SI 11 10 05
Engine

Service Action: S85 Replace VANOS High Pressure Line

E60 M5 with S85 produced up to 11/22/05

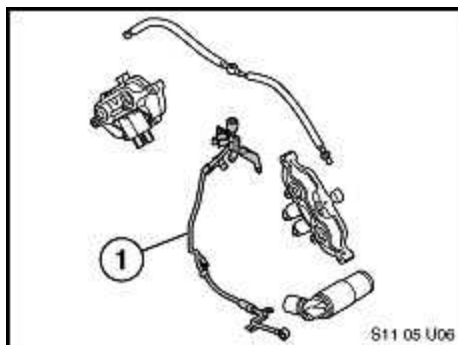
The VANOS high pressure line may start to leak engine oil around the flexible hose.

On the affected vehicles, replace the VANOS high pressure line between the pressure accumulator and connecting lead.

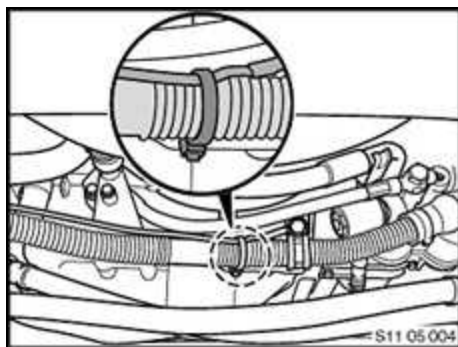
Note: When fitting the new line, make sure that there is sufficient distance to the cable tie on the secondary air hose on the bottom of the engine. If the cable tie is fitted with the lock facing upwards (towards the VANOS high pressure line) it must be replaced. When doing so, make sure the cable tie lock is positioned at the bottom (see illustration to the left).
